Planning, Land Use and Mobility Committee
Case Report / 10.3.19 / Rev 7.16.20 / Rev. 8.6.20
DIR-2019-4531-DRB-SPP-MSP / Single Family Residence
4314 Canoga Drive
Woodland Hills, CA 91364

Project Description: New Single Family Residence
Applicant / Rep: Ashraf Hemmati c. 310.709.3854; e:ashrafmemar@gmail.com
LA City Planner: Valentina Knox-Jones: 818.374.5038; valentina.knox.jones@lacity.org
Case Leader: Lauren Coffman / PLUM Chair / l.coffman@whcouncil.org
PLUM Meeting: October 3, 2019 / First Presentation
July 16, 2020 / Second Presentation
August 6, 2020 / Third Presentation

Overview of Site and Project

Site Plan

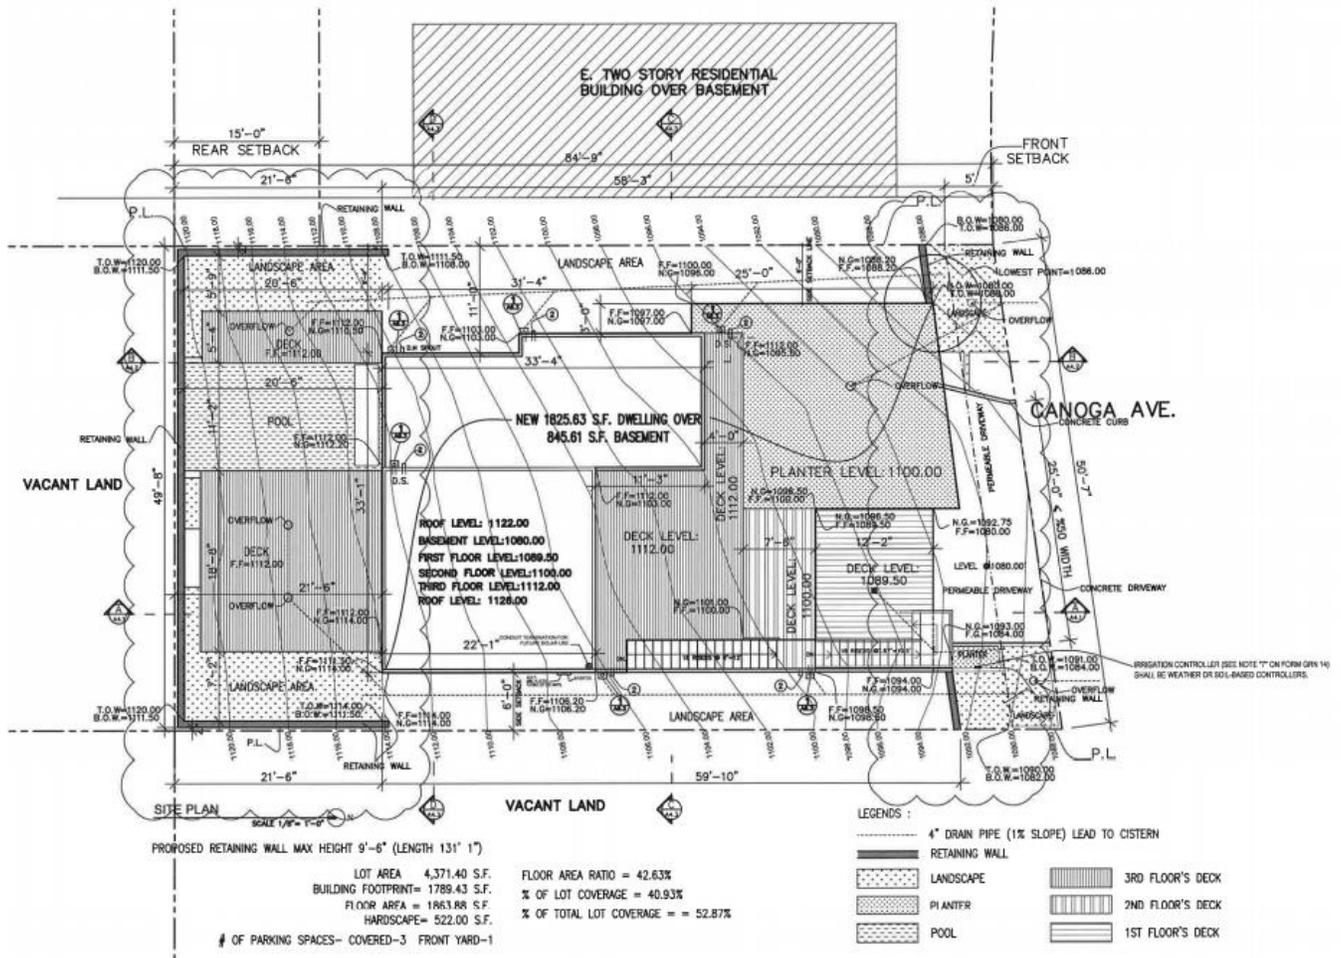
Site Drainage: Site drainage, is an issue for this site and the street, **Aside from the required planters, what is site drainage?**

1. Provide more information re: site drainage **8.6.20: Planters enlarged**
2. Locate hvac equipment on a site plan. Equipment will not be allowed on the flat roof(s) **8.6.20:Not shown**

Original Site Section

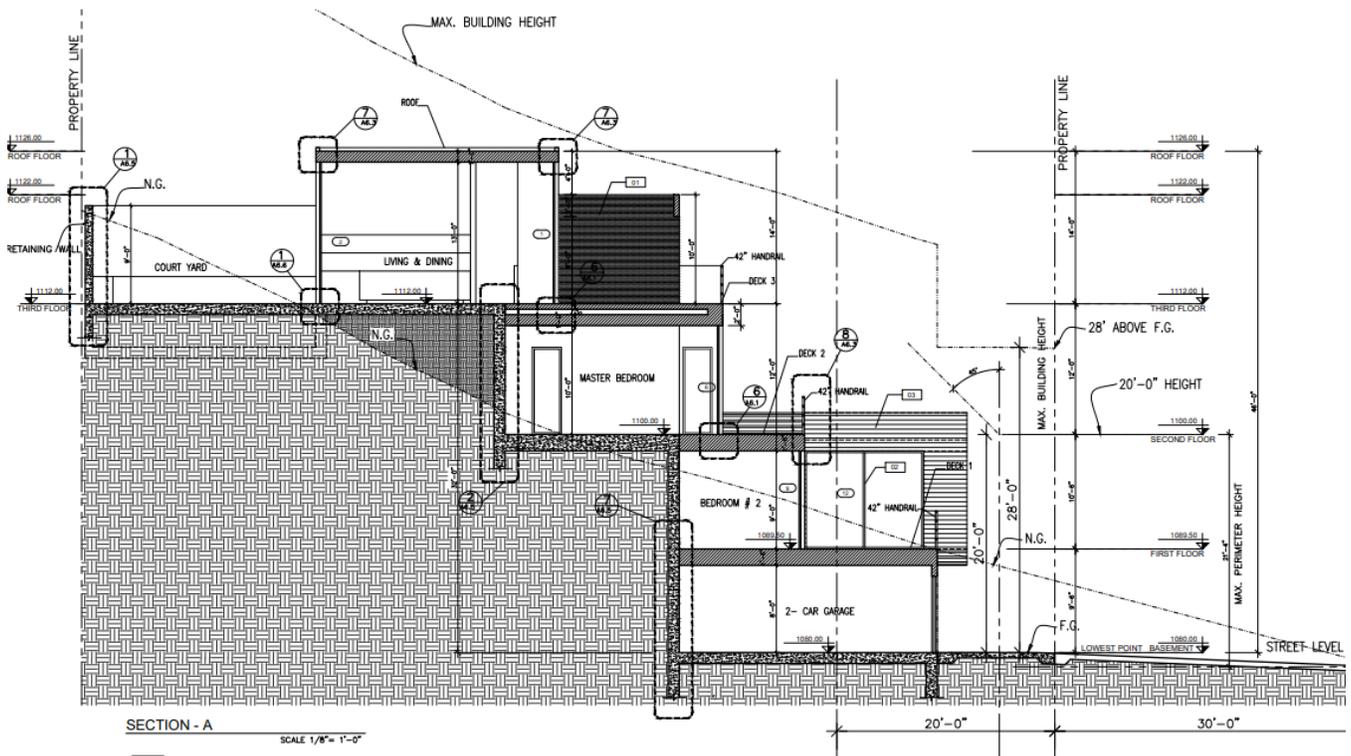
1. As per the Baseline Hillside Ordinance, the maximum envelope height for the R1-1 Zone, for a project with a roof slope less than 25% is 28 feet. This vertical height or “plumb line” height is originated at the lowest grade within 5 horizontal feet of the exterior walls of the building structure, and is the vertical distance from the grade of the site, to a projected plane at the roof structure or parapet wall located directly above and parallel to the grade.

2. The Overall Height is indicated as 50’ from finished grade to the top of the flat roof / parapet. This building appears to be taller than the allowed height of 45 feet by the *Baseline Hillside Ordinance*.

New Site Section

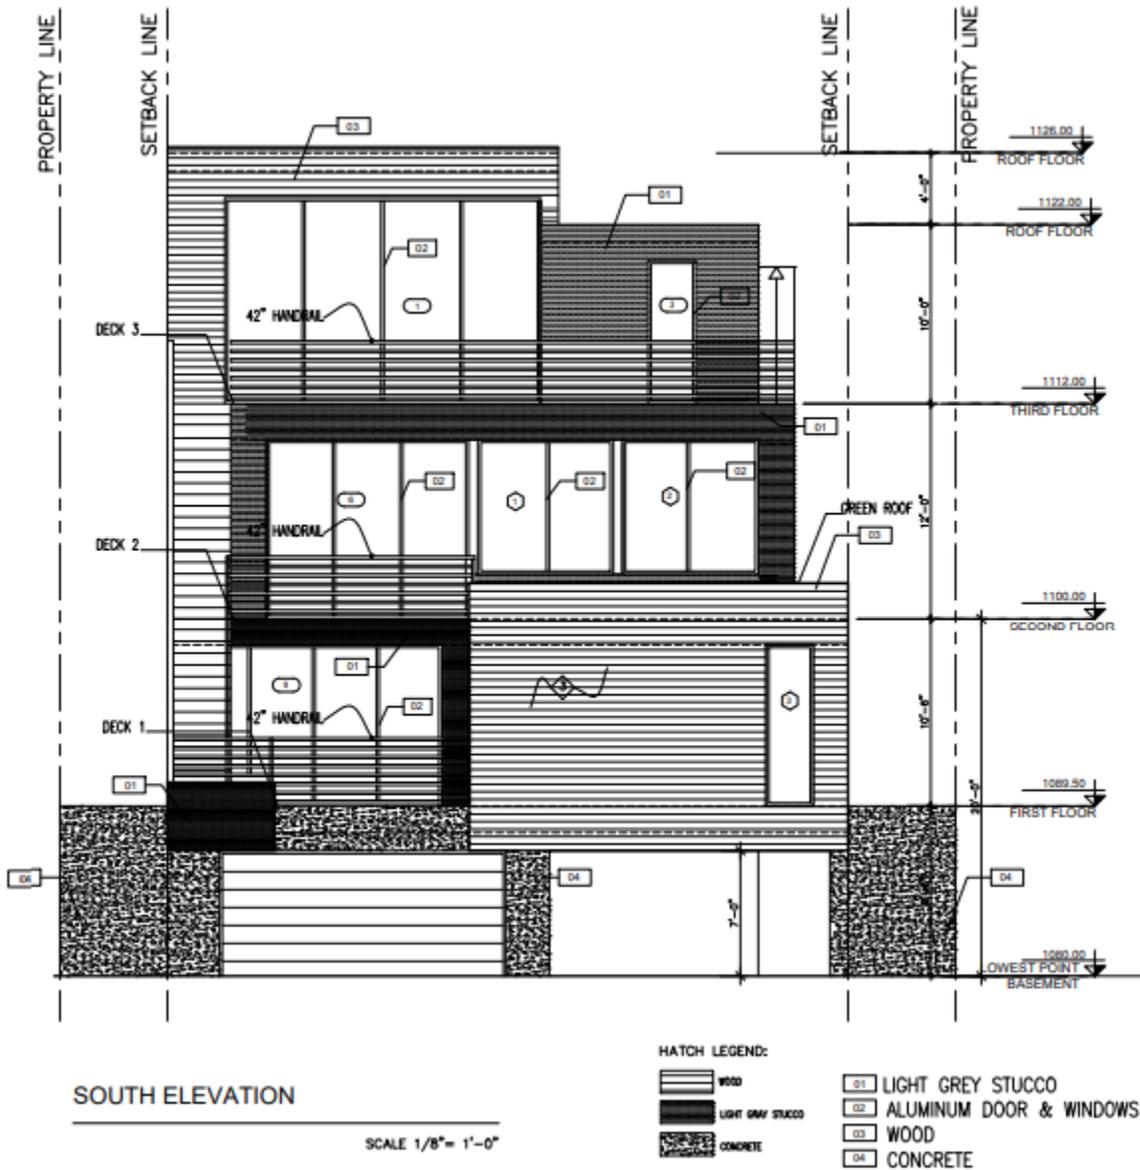
8.6.20 The projected plane needs to be 28’ from finished or natural grade, whichever is lowest. In the New Site Section, the projected plane includes a vertical cut line. This is not part of the projected plan, as it is a vertical cut in the projected plan, where the site is being cut back as needed to conform with the 30’ wide required street upgrade. As per the definition of grade in the baseline hillside ordinance, *For the purpose of measuring height on an R1, Rs, Re or RA zoned lot in the Hillside Area, pursuant to section 12.21.C.10 of this code, Hillside Area Grade shall be defined as the Elevation of the finished or natural surface of the **ground**, whichever is lower, or the finished surface of the **ground** established in conformance with a grading plan approved pursuant to a recorded tract or parcel map section.* The vertical cut of the ground should not be considered the grade. Therefore, the projected plan should be set at 28’ above the finished grade, which is the driveway.

8.6.20: As per the New Site section, which shows the street, the building seems to comply.
